Planning Officer's Report – LDCA JANUARY 2025

APPLICATION	2024/57 – Proposed Installation of Draped Mesh Netting (R2 Project)
PERMISSION SOUGHT	Full Permission
REGISTERED	10 th October 2024
APPLICANT	Capital Programme Section c/o Mr Kyle Shoesmith
PARCEL	AF0387
LOCALITY	Side Path & Field Road Junction
ZONE	Coastal
CONSERVATION AREA	Jamestown Historic
PUBLICITY	The application was advertised as follows: <ul style="list-style-type: none">▪ Sentinel Newspaper on 14th November 2024▪ A site notice displayed in accordance with Regulations.
EXPIRY	28 th November 2024
REPRESENTATIONS	One Received
DECISION ROUTE	Delegated / LDCA / EXCO

Revised drawing FR 005/2

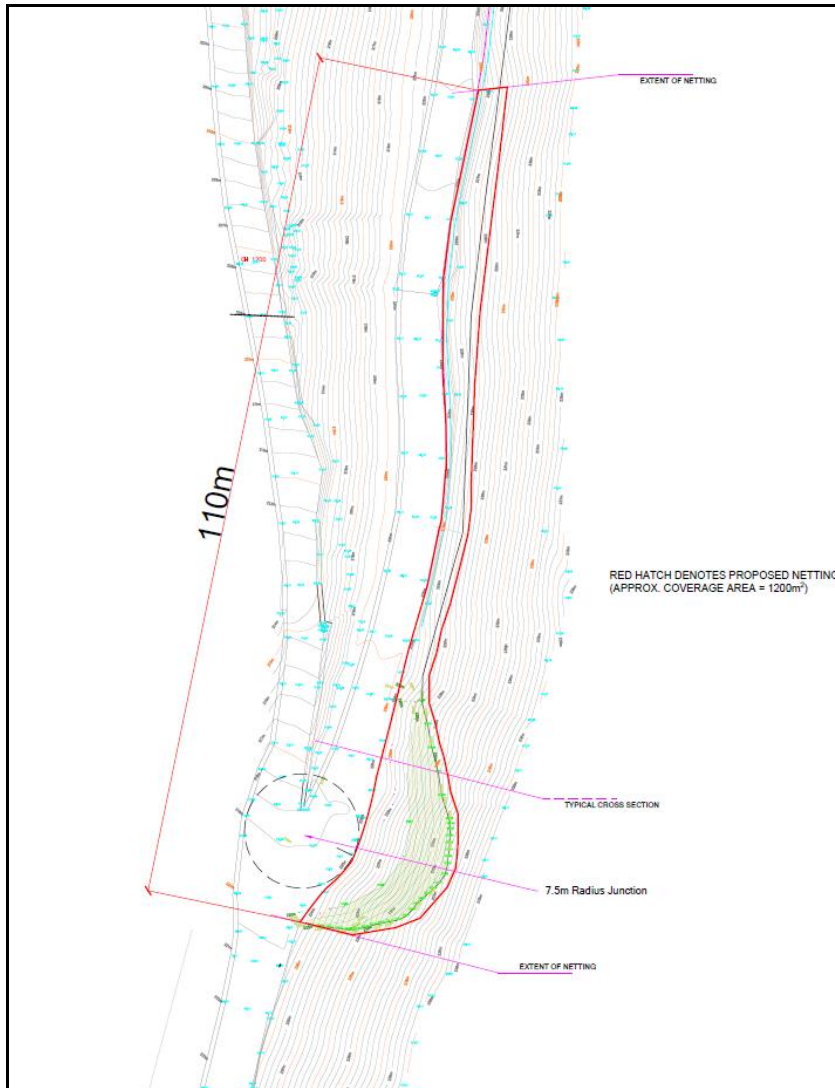
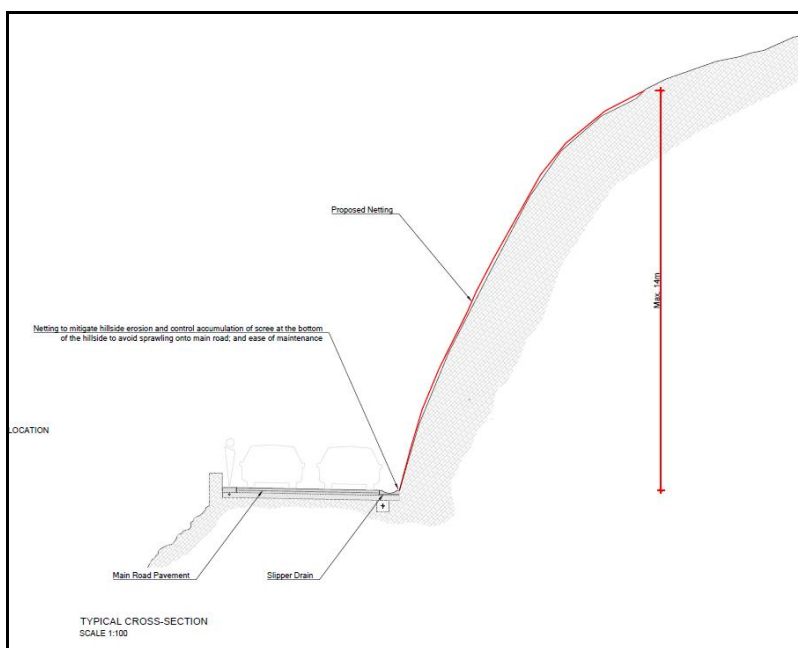
There is no explanation as to why this drawing has been revised. Why is it?

The principal difference in this revision is the location of the 'Typical Cross Section'. The two different 'Typical Cross Sections' show very different bank heights but both are claimed to be 14m. That does not make sense. Can you please explain.

The base of the netting adjacent to the road Junction has been altered in the revised drawing no 2. It states the 'Approx Coverage Area' of the netting is 1200sq m, which is double that of the previous drawing. It would appear unlikely that the revised netting base-line could explain the doubling of the netted area. The doubling of the netted area was not mentioned in the planning consultation as advertised on 14 November 2024. Can you please explain this.

Diagram 5: Front Elevation of Netting

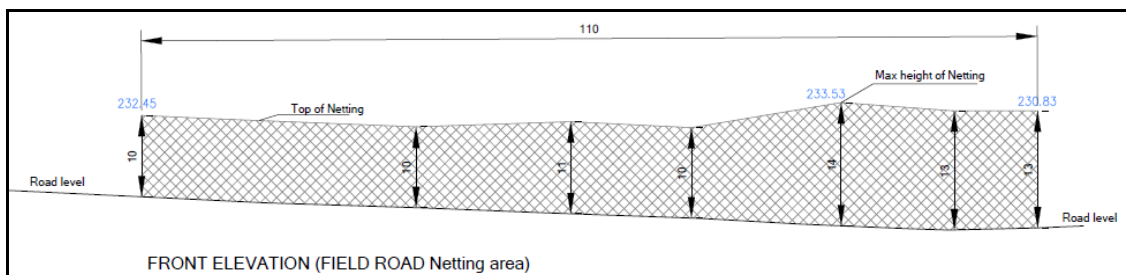
While the area of the netting is stated to have been doubled, the elevational drawing remains unchanged. There is clearly a very large discrepancy which needs to be publicly accounted for.

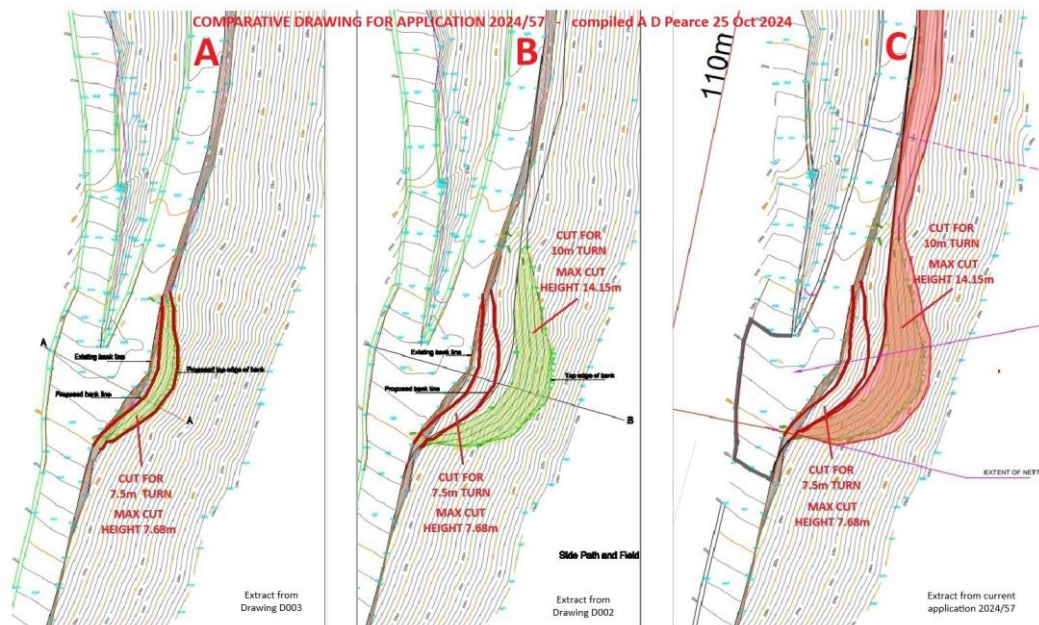
I attach a comparative drawing showing the current application 2024/57 (see C) and the two alternative proposals in the original application 2022/87, as approved by Exco 12 Dec 2020. They are approved drawings D002 (see B) and D003 (see A).

The purpose of the 7.5m turn was to reduce the 14m cut height that would have been necessary with a 10m turning (see B) in order to reduce the impact on the landscape. The cutting for the 7.5m turn would only be about 7m high (see A).

The written statement says the that during excavation it was found possible to safely have a higher angle of repose, meaning the cut is now steeper than shown in the original application (see A). The geometrical logic of a steeper bank means the cutting height must be less than the 7m as originally proposed.

This application drawing contradicts that logic and so makes no sense at all. The drawing shows a 10m turn and a 14m high cut (C), not the 7m turn (A) that the applicant says was made.

[Officer comment: Minor amendments have been made to correct the plans]
